CORRECTIVE MEASURES STUDY REPORT SOLID WASTE MANAGEMENT UNIT 17
(SWMU 17) ZONE H CNC CHARLESTON SC
11/30/2004
CH2M HILL

SWMU 17. Zone H

Re: Corrective Measures Study Report (Revision 0) – SWMU 17, Zone H

Re: Responses to SCDHEC Comments on the *Corrective Measures Study Report, SWMU 17, Zone H, Revision 0* – Originally Submitted on November 30, 2004

Figure 2-6
 COC Detections in Groundwater Since 1999
 SWMU 17 CMS Report
 Charleston Naval Complex

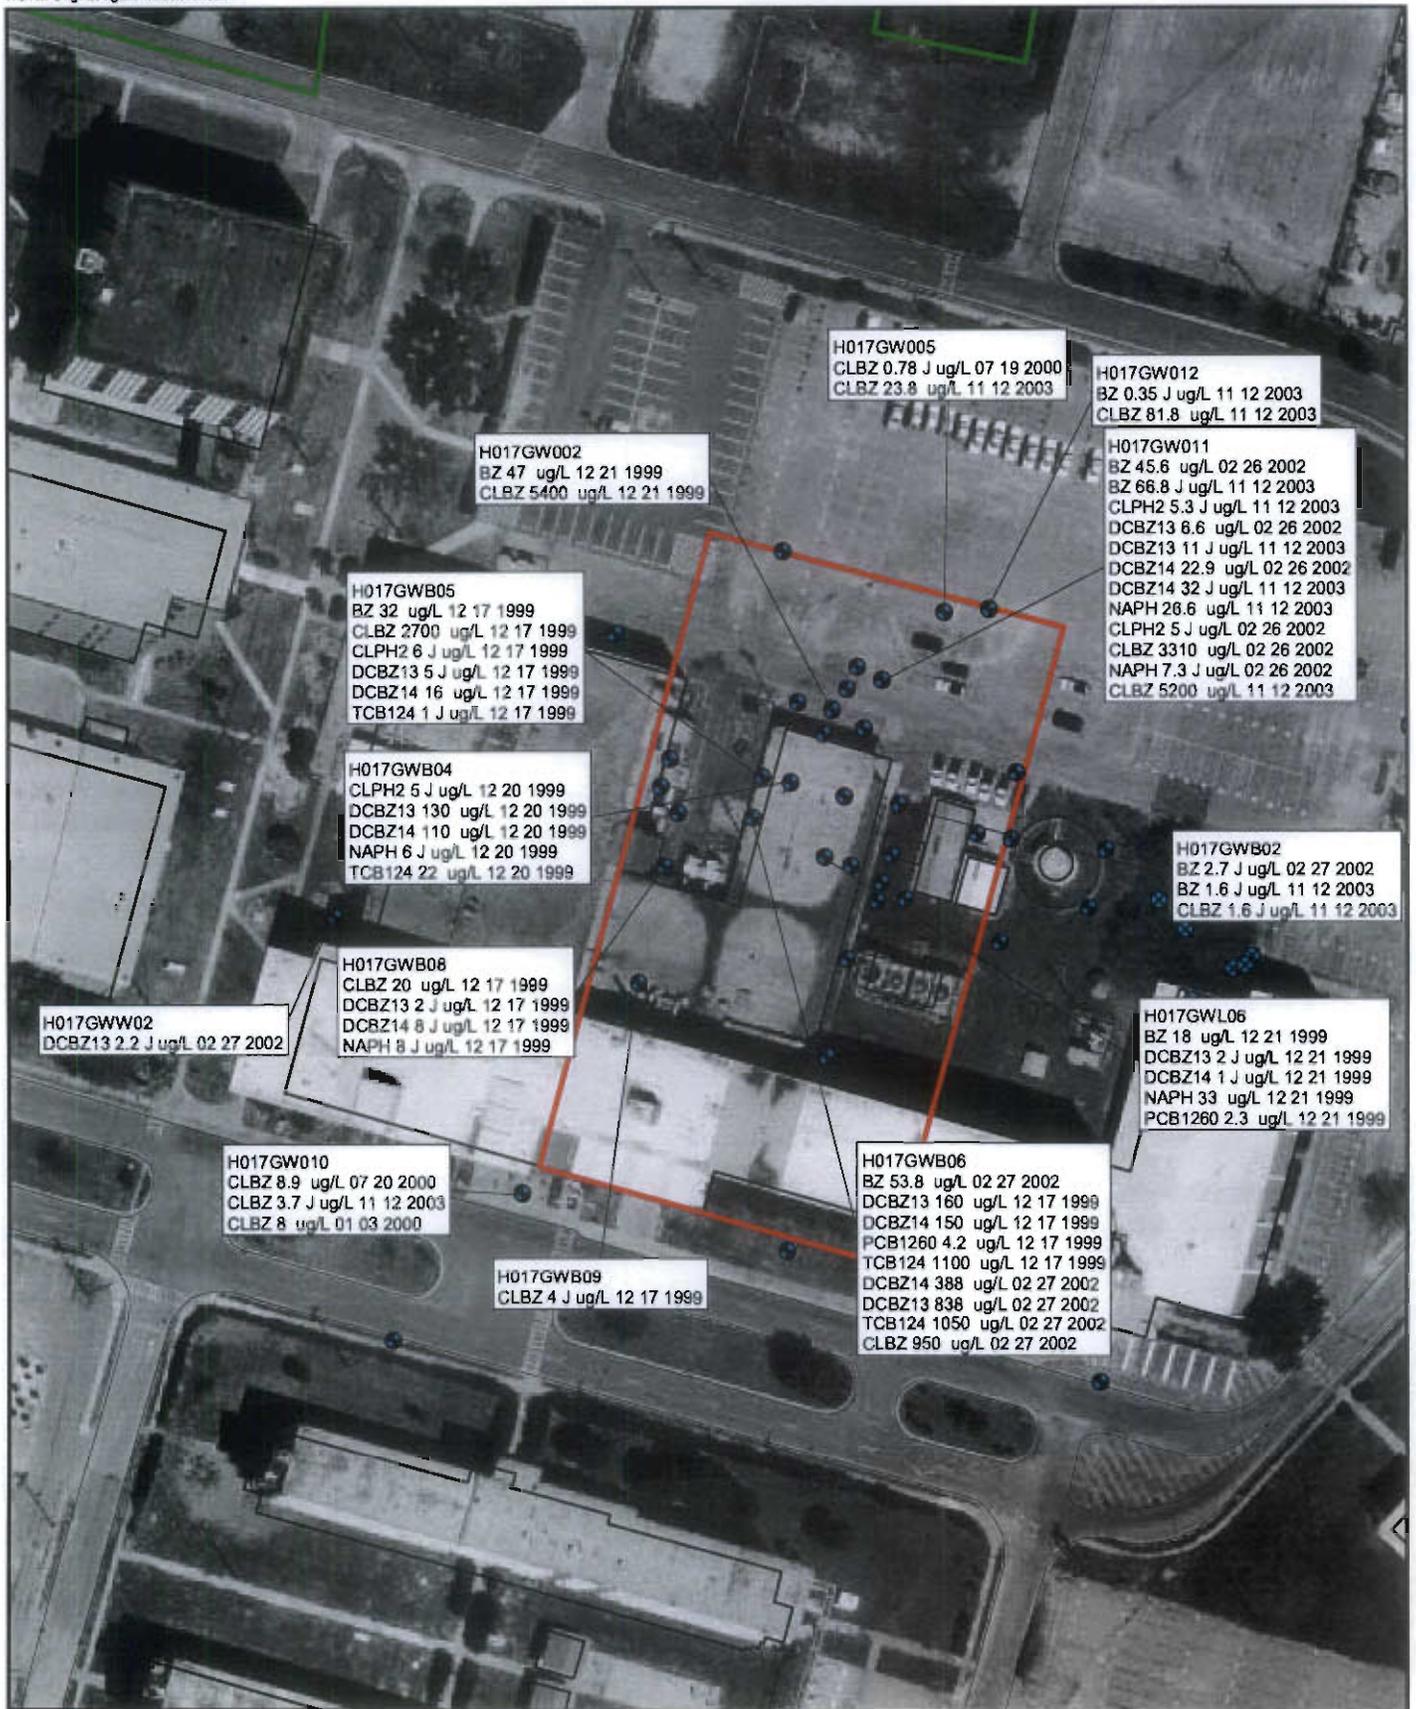
4. **Figure 2-6, Table 3-3**

The maximum detections provided in Table 3-3 do not appear to be listed on Figure 2-6. Please clarify.
